Our ref: 19310.6

14 February 2021

**RE: Response to Further Request for Additional Information – DA-2020/035 – 262 Hunts Road
Gunnedah NSW 2380**

Figure 1

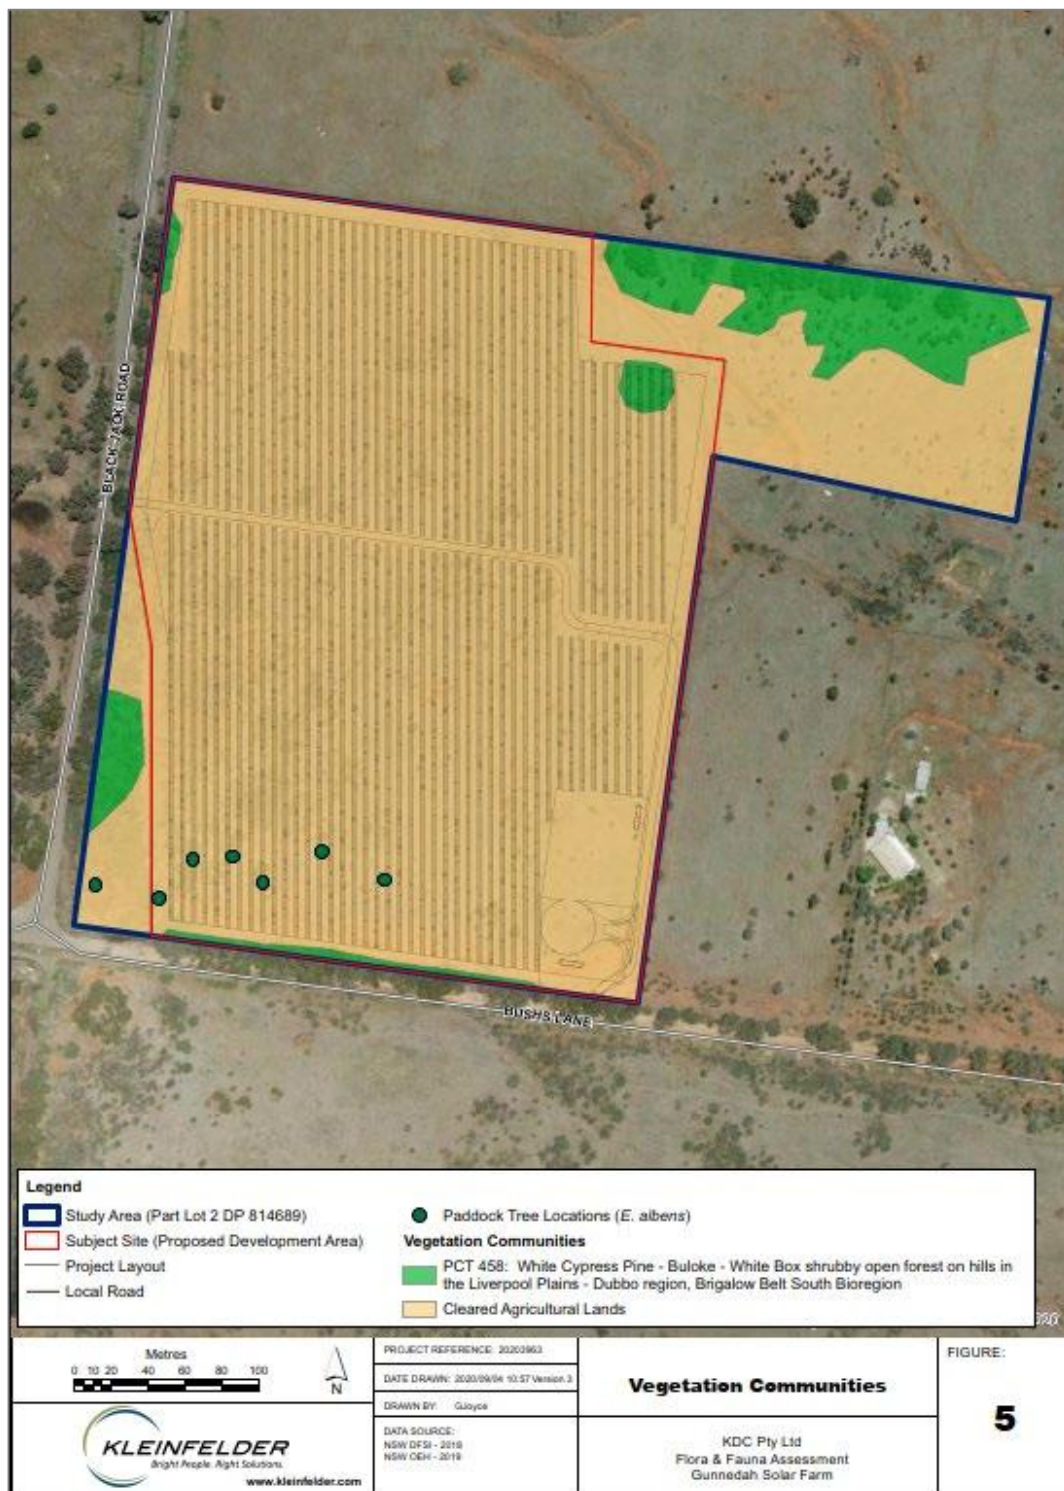
The vegetation clearing noted on plan prepared by DRB consulting engineers, ref: 200336, Dwg No. CIV01 and CIV02, indicating vegetation in North-East and North-West corner of the site which will be developed by solar arrays. Does the potential removal of vegetation exceed area capacity exceed BOS thresholds within the Biodiversity Conservation Act 2017? What is the BOS threshold and has it been exceeded by the proposed vegetation clearing as a result of this development?

- The proposed development will not involve clearing of native vegetation that exceeds the Biodiversity Offset Scheme (BOS) clearing threshold for the site (0.5 ha threshold for a minimum lot size of 10 ha) as determined by the BC regulation. In performing the threshold exceedance calculations, the areas of native vegetation in the northwest and northeast corners of the development were included, in addition to the isolated trees in the southern portion. Refer to Enclosure C for further discussion.

Please refer to Figure 1.

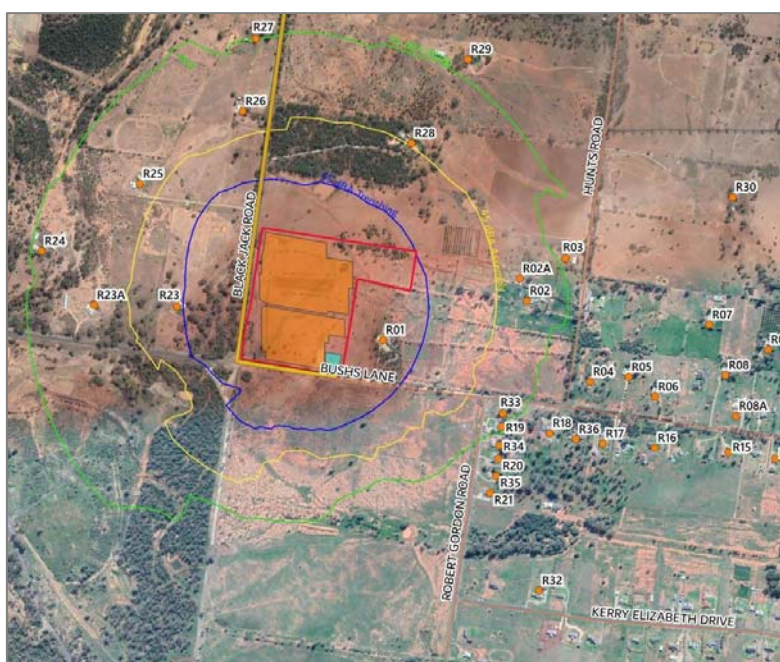
The noise assessment did not include all residences along Robert Gordon Road, being close receivers to the development and potential exceedances. The noise assessment should be updated to investigate each dwelling within the immediate affected area, including those not shown on aerial imagery.

An amended noise assessment has been provided to include additional receivers along Robert Gordon Road. Refer to Enclosure D for further discussion.
